ADDENDUM# 3

**University of Kentucky
2555.0 Delta Gamma House New Construction**

Addendum #03

Written Questions and Answers

ISSUE DATE
09/30/2022
JOB NO.
11476-00
DWG. NO.
A622

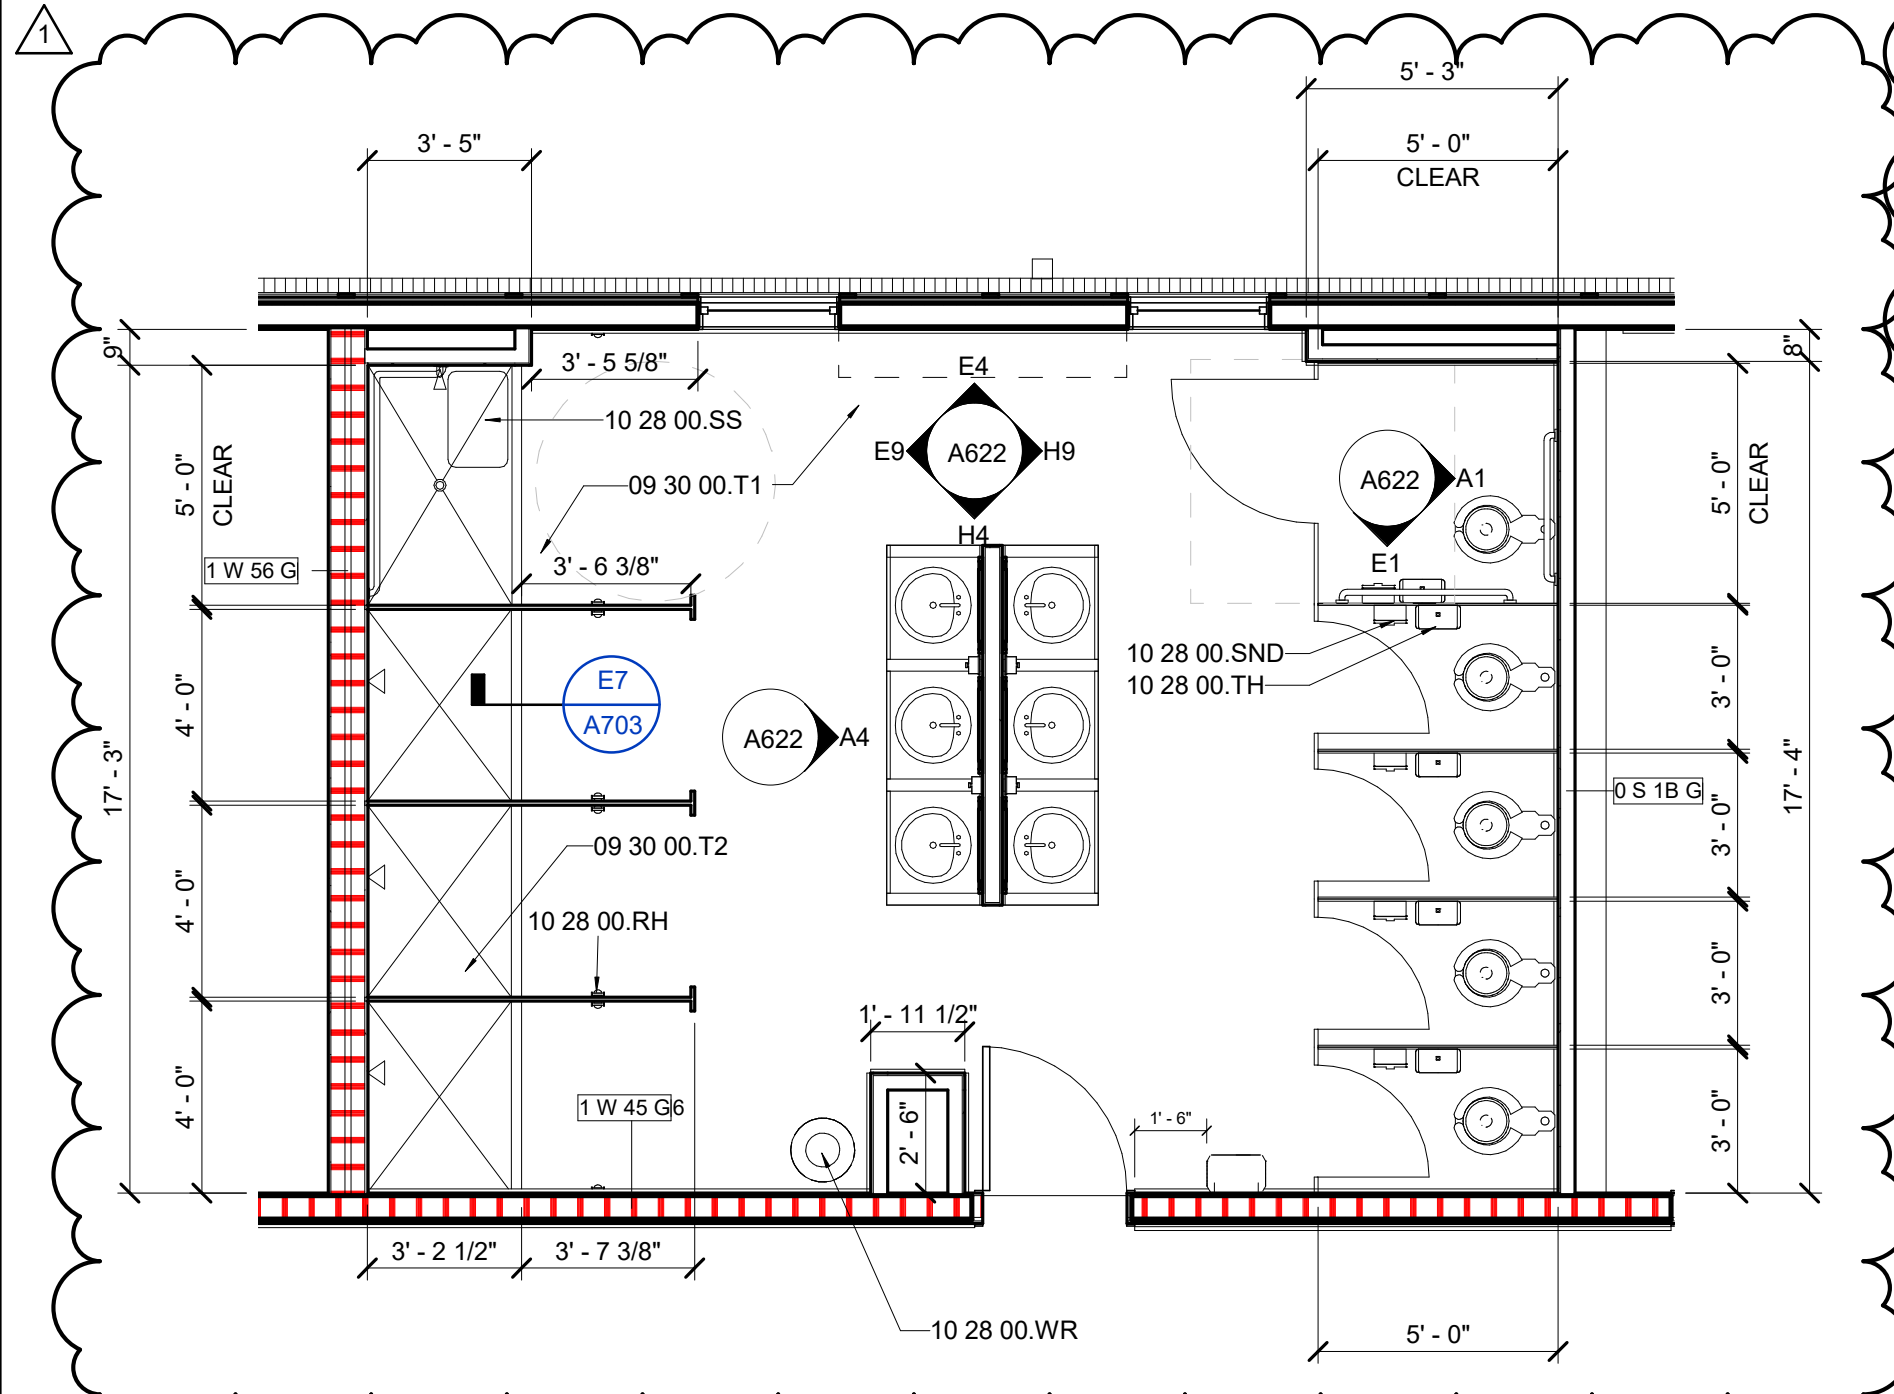
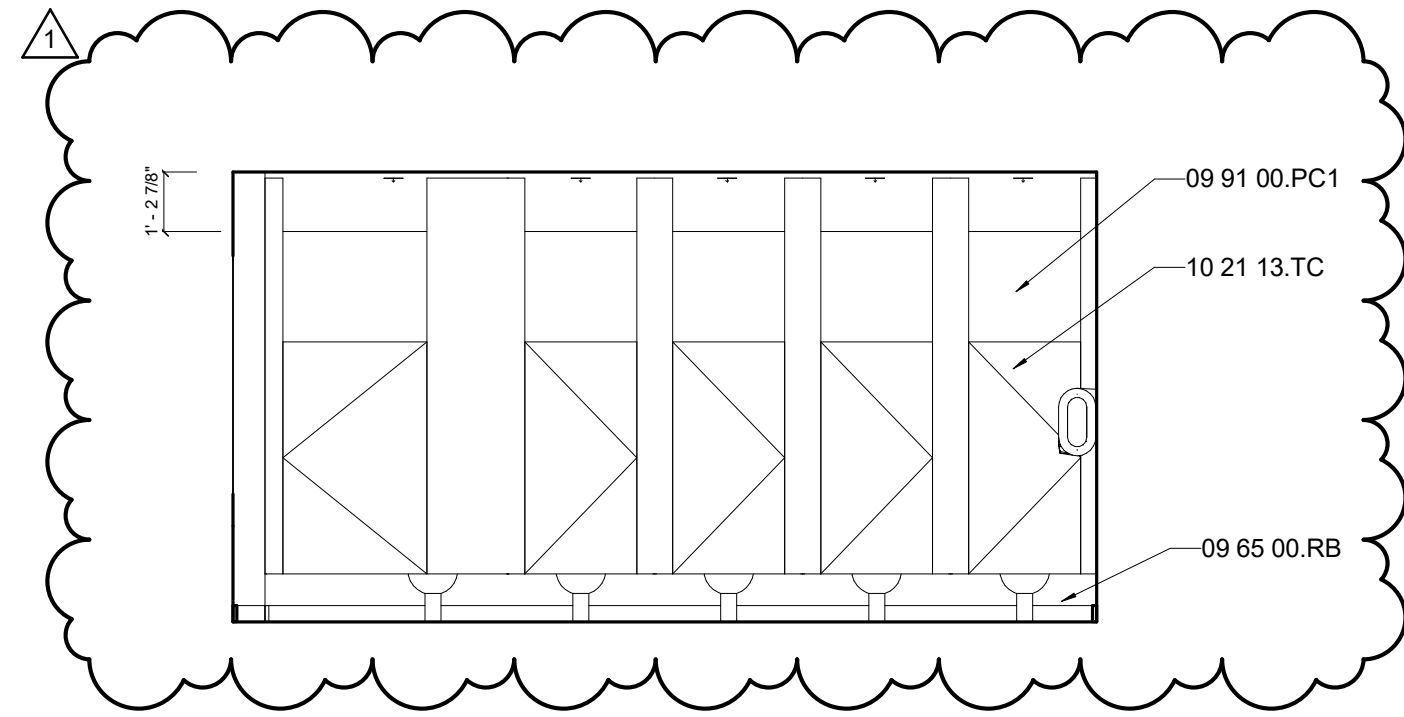
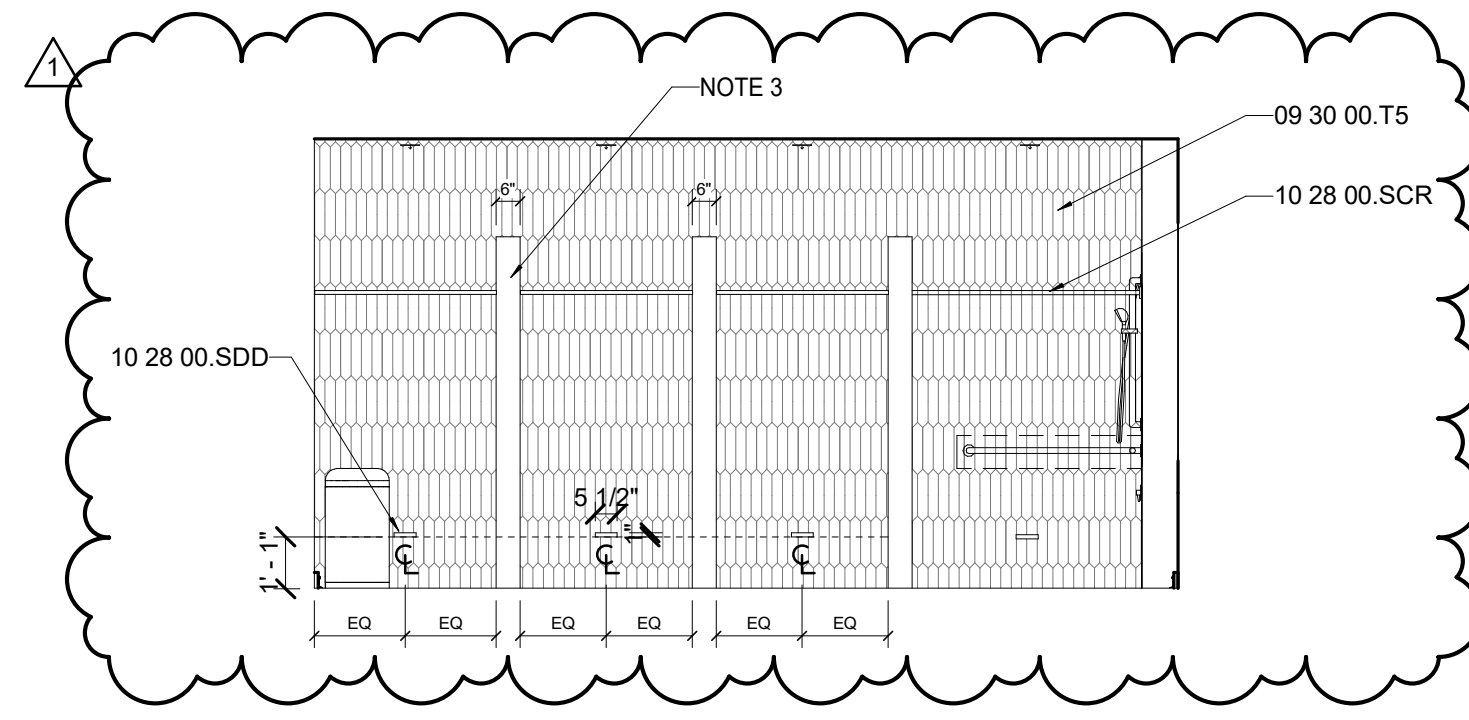
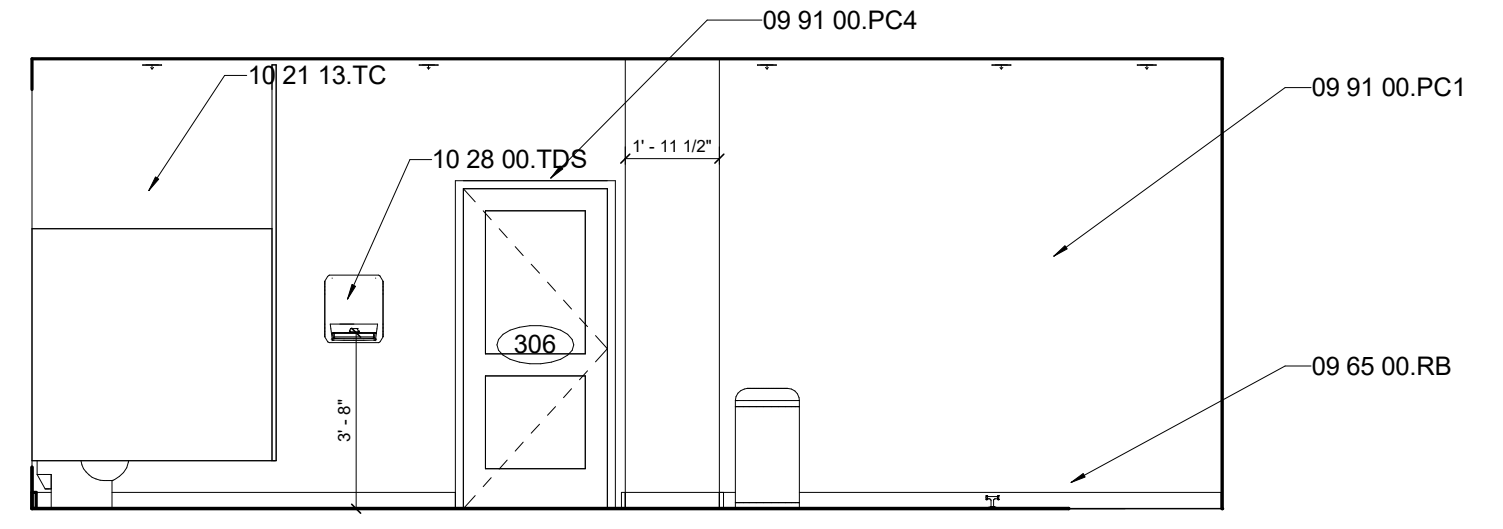
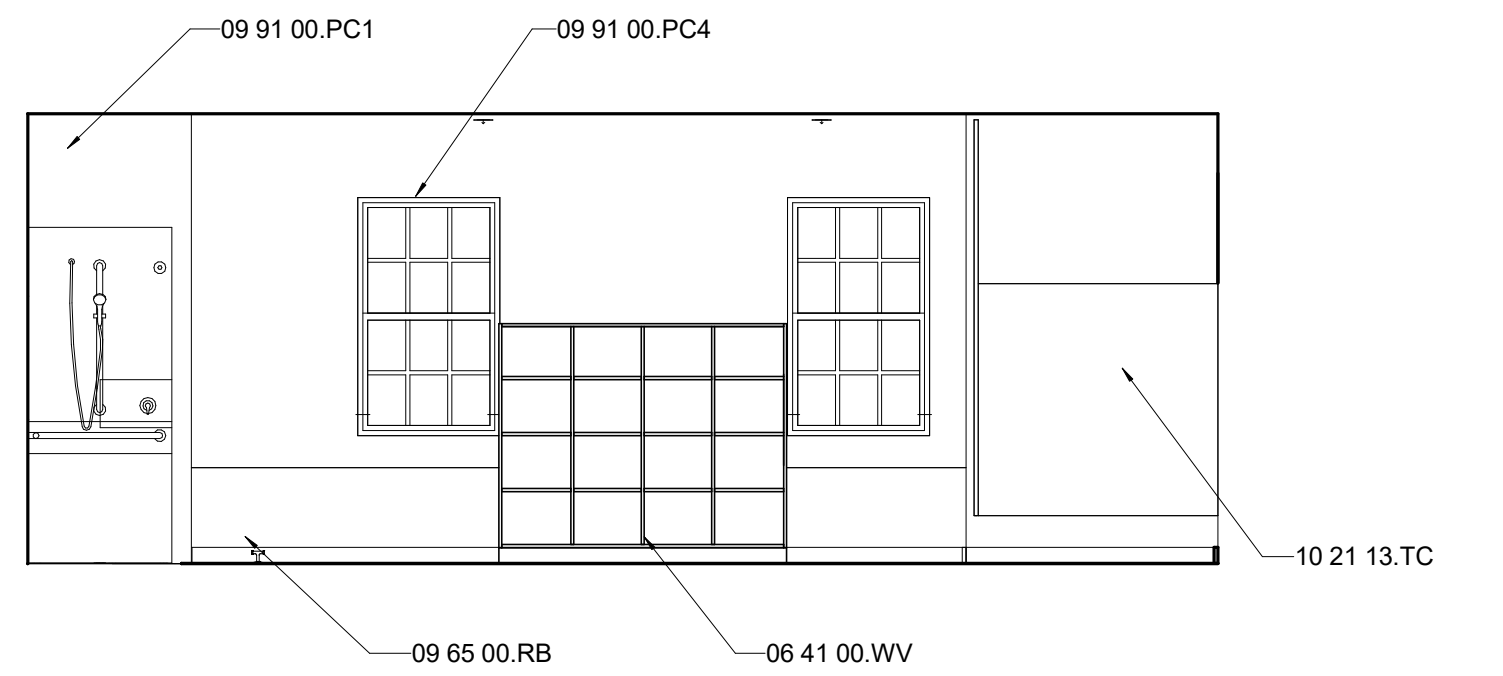
25.	<p>Question about the RR drawings please. Room 206 & 306 have T2 listed as a floor tile on the Interior Finish Plan(A701). The finish schedule(A700) T2 is listed as a wall tile and in the interior drawings (A621 & A622) shows the tile being installed in what appears to be an ADA Pre-Fab Bathtub. In the RR elevation drawings(A621 & A622) they show what appears to be two different wall tiles (E9 & G5) with only T5 designated. We assume the second undesigantated tile is T2, as that is the ADA shower and tub. My question is: do they want T2 installed in the ADA tub and shower as both wall and floor tile, wall tile only or am I totally out to lunch on this? Could you please advise?</p>	LAS	<p>Bathroom elevations have been revised to reflect intended design. There are no pre-fab showers in the main restrooms.</p> <p>The wall tile is T5 as shown on revised elevations. T2 is floor tile only.</p> <p>For clarification, T3 has been removed from the project.</p> <p>Please refer to revised sheets A621 and A622, attached.</p>

39.	For Spec Section 102113 – Toilet Compartments – Elevations in the plans show compartments that look to be overhead braced/floor mounted, however specs state ceiling hung. Please Advise.	LAS	Toilet compartments will be ceiling-hung as specified. Drawings have been revised to reflect this. Refer to revised Sheets A621 and A622, attached.

A621	ENLARGED RESTROOM PLAN & ELEVATIONS <ul style="list-style-type: none"> Clarifications in response to Contractor questions. 	10/26/22
A622	ENLARGED BATHROOM PLANS & ELEVATIONS <ul style="list-style-type: none"> Clarifications in response to Contractor questions. 	10/26/22
A631	ENLARGED UNIT PLAN & ELEVATIONS <ul style="list-style-type: none"> Clarifications in response to Contractor questions. 	10/26/22
A700	INTERIOR FINISH LEGEND <ul style="list-style-type: none"> Finish Material clarifications - Tile 	10/26/22
CE3	SPOT ELEVATION PLAN <ul style="list-style-type: none"> Revised spot elevations 	10/26/22
CE4	SPOT ELEVATION PLAN – ALTERNATE #1 <ul style="list-style-type: none"> Revised spot elevations 	10/26/22
EC1	EXISTING CONDITIONS PLAN <ul style="list-style-type: none"> Utility clarification in response to Contractor questions. 	10/26/22
LH101	SITE PLAN <ul style="list-style-type: none"> Material update to remove pavers. 	10/26/22

SHEET TITLE
SITE PLAN - ALTERNATE #1

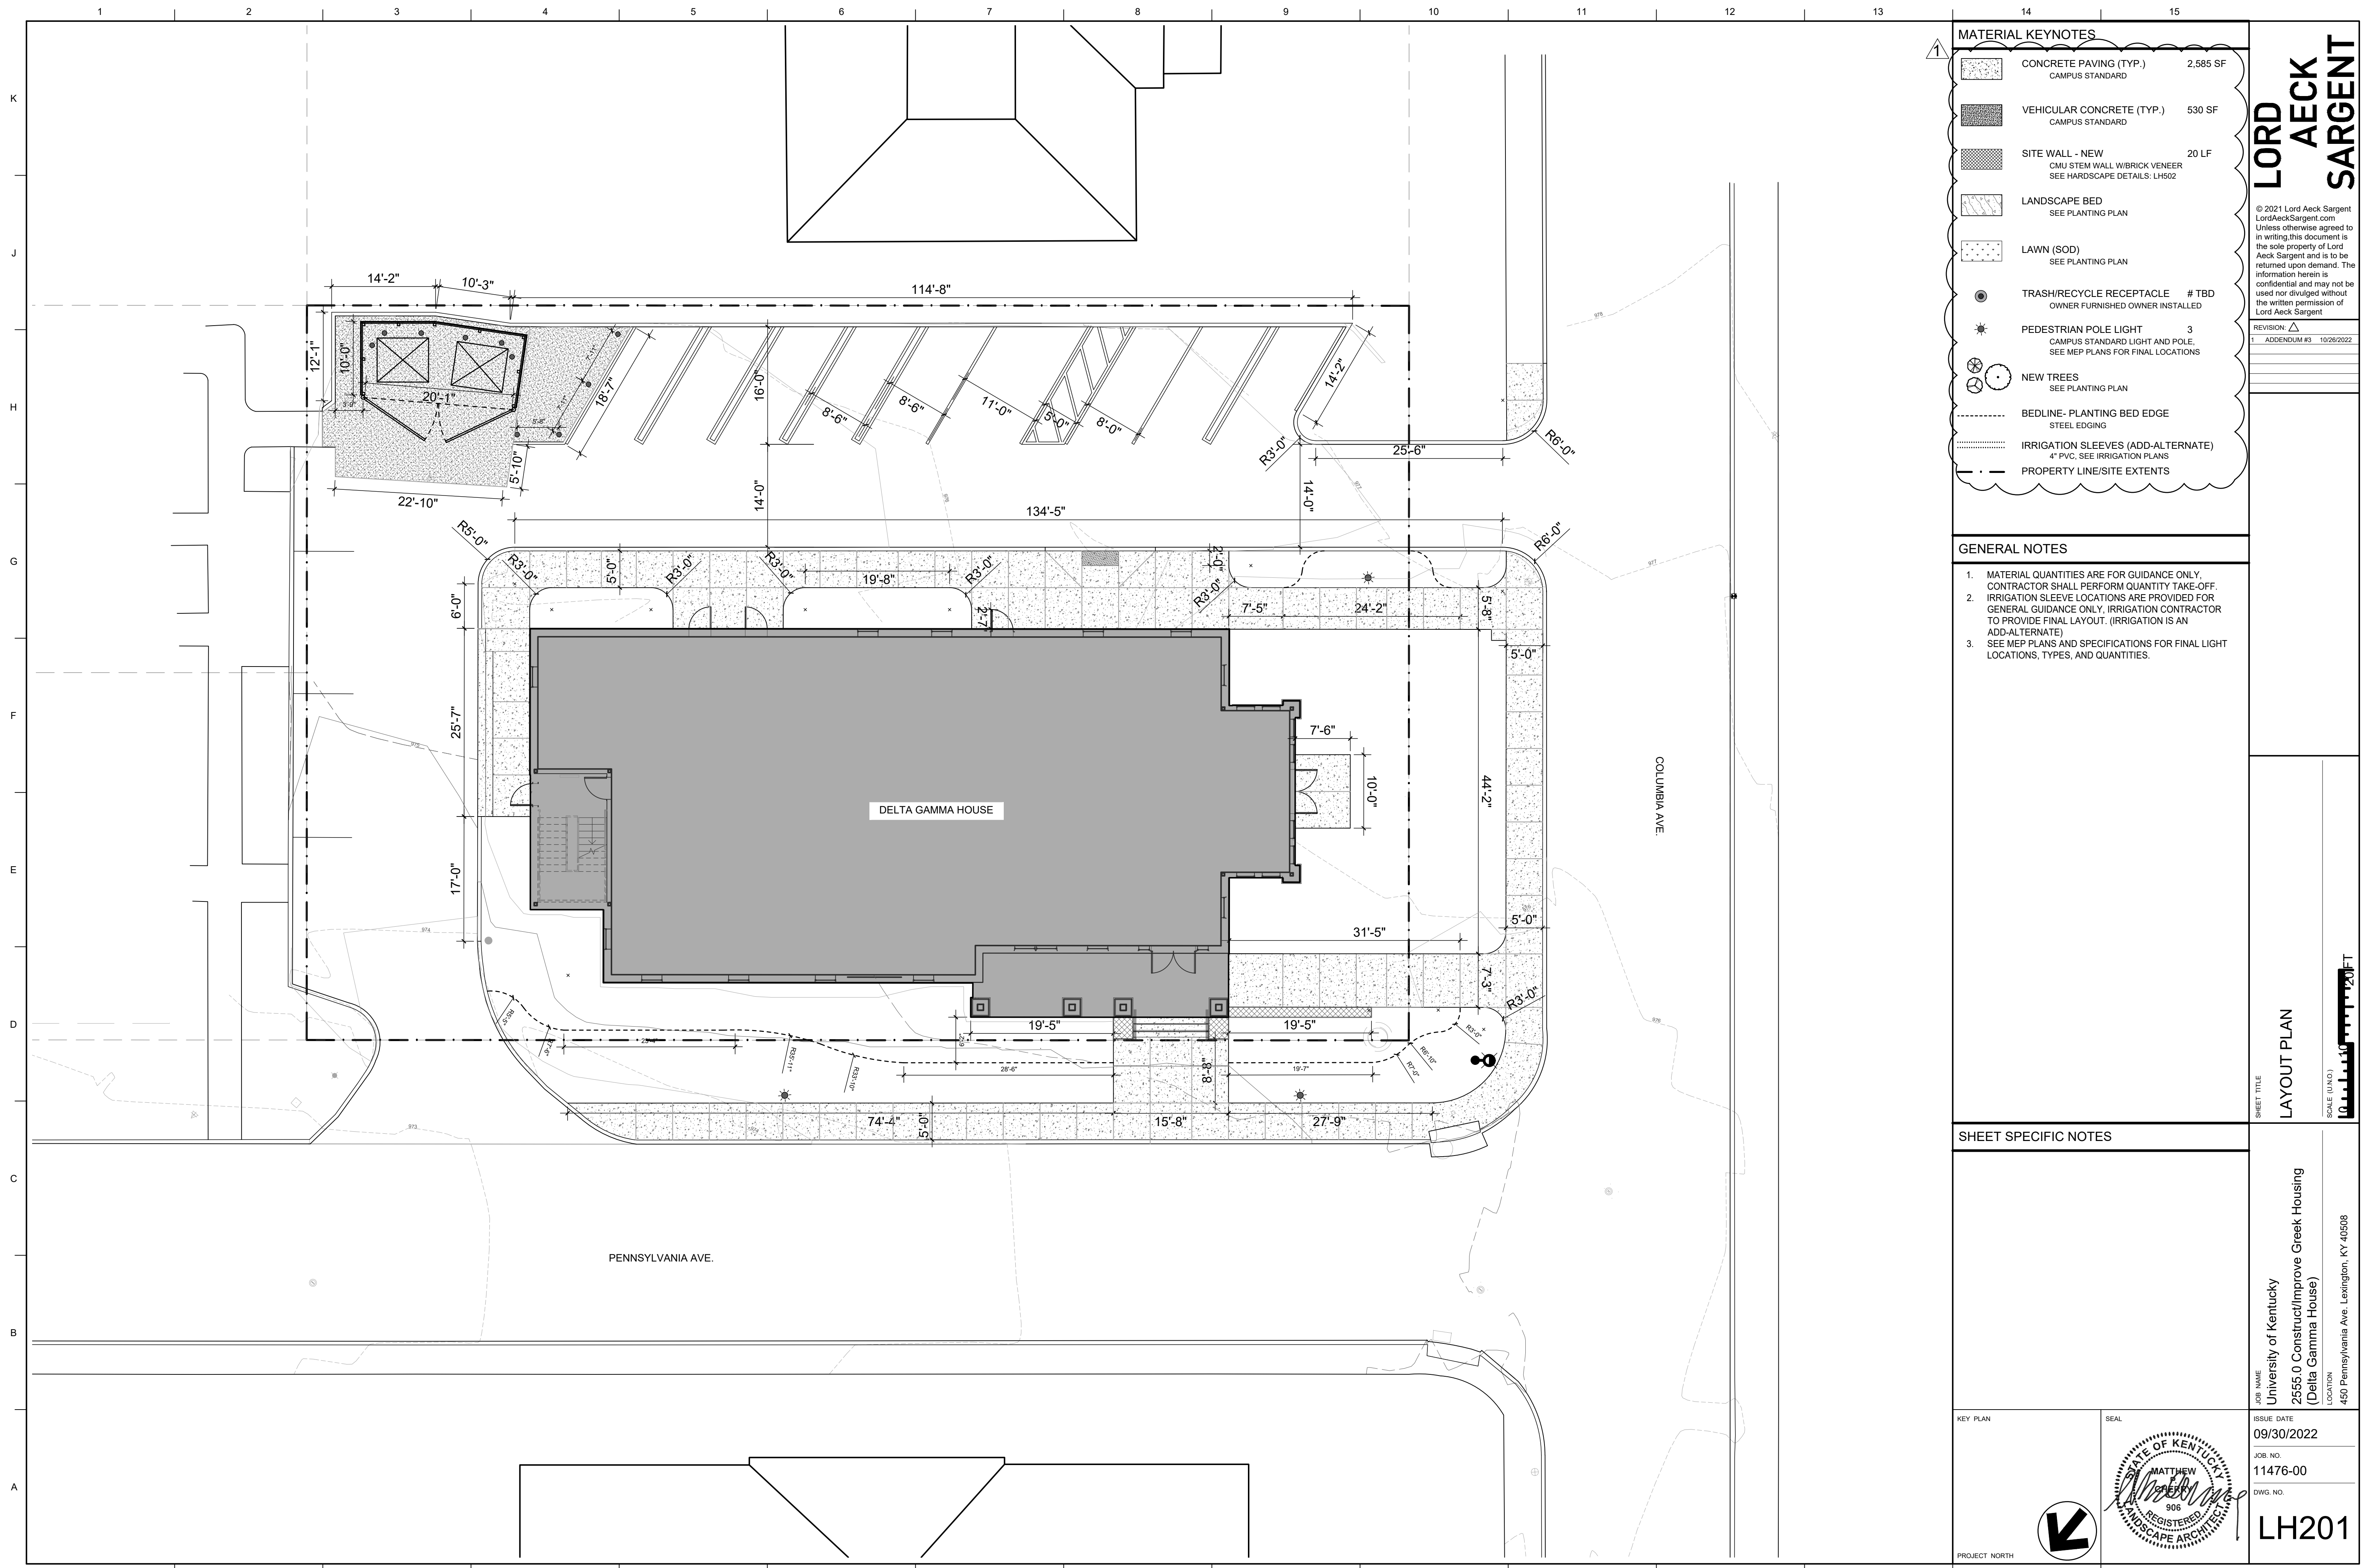
LH102	SITE PLAN – ALTERNATE #1	10/26/22
	<ul style="list-style-type: none">• Material update to remove pavers.	
LH201	LAYOUT PLAN	10/26/22
	<ul style="list-style-type: none">• Material update to remove pavers.	
LH202	LAYOUT PLAN – ALTERNATE #1	10/26/22
	<ul style="list-style-type: none">• Material update to remove pavers.	
P001	UNDERFLOOR PLUMBING PLAN	10/26/22
	<ul style="list-style-type: none">• Add mop basin in Dry Storage Rm 134A per Jurisdiction Review	
P101	SANITARY WASTE AND VENT PLUMBING PLAN – LEVEL 01	10/26/22
	<ul style="list-style-type: none">• Add mop basin in Dry Storage Rm 134A per Jurisdiction Review	
P201	DOMESTIC WATER PLUMBING PLAN – LEVEL 01	10/26/22
	<ul style="list-style-type: none">• Add mop basin in Dry Storage Rm 134A per Jurisdiction Review	
P400	PLUMBING RISERS	10/26/22
	<ul style="list-style-type: none">• Add mop basin in Dry Storage Rm 134A per Jurisdiction Review	
P402	PLUMBING RISERS	10/26/22
